Agenda for 6th TeST Meeting

AGENDA OF 6TH TELECOMMUNICATION, SCADA AND TELEMETRY SUB-COMMITTEE MEETING TO BE HELD ON 08.07.2020 (WEDNESDAY) AT 10:30 HOURS

R phase to earth fault.

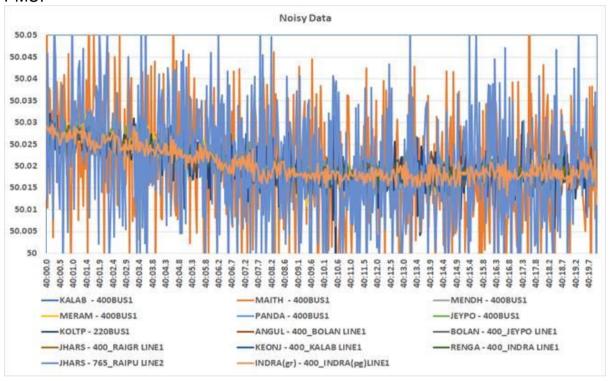
S no	Station Name	Observation	
01	Ranchi	Discrepancies in PMU measurement at Ranchi during fault of 400 kV Ranchi Sipat – 2 on 15-06-2020 at 07:56 hrs	
		PMU observation:	
		As per voltage plot at Ranchi: B Phase to earth fault	
		As per current plot at Ranchi: Y and B phase to earth fault	
		As per voltage plot at Rourkela: B phase to Earth fault	
		DR recorded at Ranchi:	
		B phase to earth fault.	
02	Barh STPS	Discrepancies in PMU measurement at Barh during fault of 400 kV Barh – Motihari – 2 on 20-05-2020 at 13:23 hrs	
		PMU observation:	
		As per line voltage plot at Barh of 400 kV Barh Kahalgaon - 2: B Phase to earth fault	
		 As per line voltage plot at Barh of 400 kV Barh Motihari - 2: R phase to earth fault 	
		DR recorded at Barh:

Figure 1: Summary of vulnerable relays.

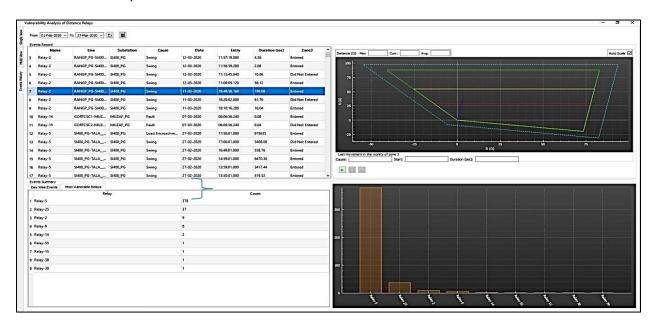
- ➤ Relay 5, (corresponding to line Binaguri –Tala 1) is abruptly coming in list of vulnerable relays which is not correct, sometimes cause is showing swing and sometimes load encroachment. Although the line is out of service since 06 feb still it is appearing as shown in below snapshot. As shown below it has appeared 378 times in 2 months. Many a times it is seen that within 1 minute this relay is appearing 5 to 6 times.
- Similarly **Relay 25** (Corresponding to **Biharshariff –sasaram** line) has also appeared 37 times for the same reason load encroachment or swing. It was checked for many instances of time stamping shown as swing but there was no fault or power oscillation during that period was found ,still it is coming .In Figure (2) power flow of same line is shown where no swing or abnormality was found .

Figure(3) Relay 2 trajectory as shown by circle in above figure.

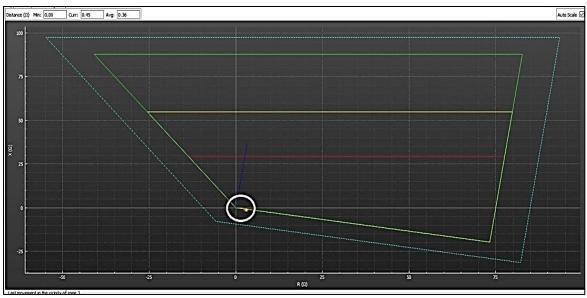
➤ Relay 2 corresponding to (400 Kv Binaguri - Rangpo) has also appeared 9 times for the reason of swing ,fault trajectory of relay shows it in zone -3 but no such fault or any abnormality found in nearby area .Line is already out from past few months for reconductoring work still it is appearing .

Figure (4) Relay 57 (Binaguri – Kishanganj line) trajectory as per application)

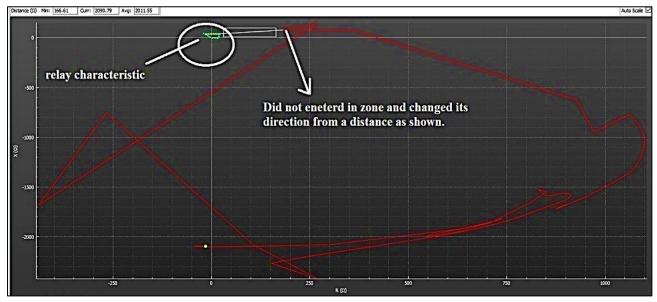
Operating point trajectory of fault is shown by Red color line in below figure.

Relay characteristic is shown by green color quadrilateral as encircled in below figure.

Relay setting for the line has been checked and found ok still it did not entered in any zone.

Figure(5) prior to fault operating point .

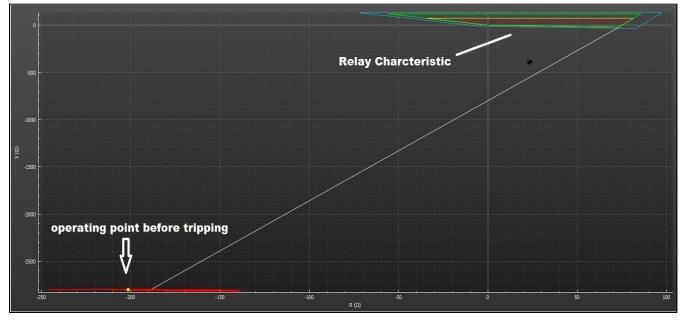
➤ CASE II: Similarly in recent tripping case of 400 Kv Patna –Kishanganj I at 19:37 Hrs due to B-N fault on 13 March. Relay 55 trajectory was observed prior to fault and during fault .As shown in below figure (5) prior to fault operating point was far away from relay characteristics zone .

Figure(6)operating point trajectory during fault .

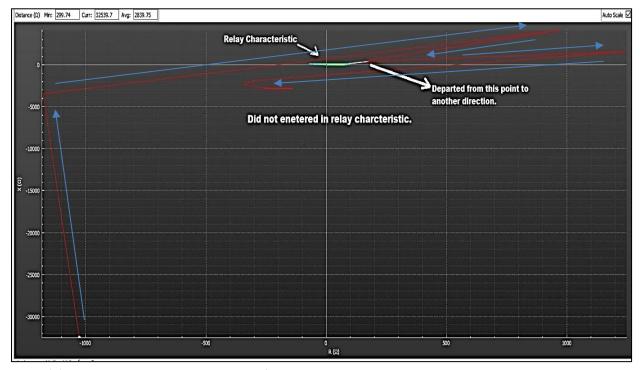
Relay trajectory during fault is shown in figure (6) which shows that due to fault operating point moves towards relay characteristic but did not entered in any zone and departs from a distance which should not occur as in reality there was a B-N fault in the line and line tripped.
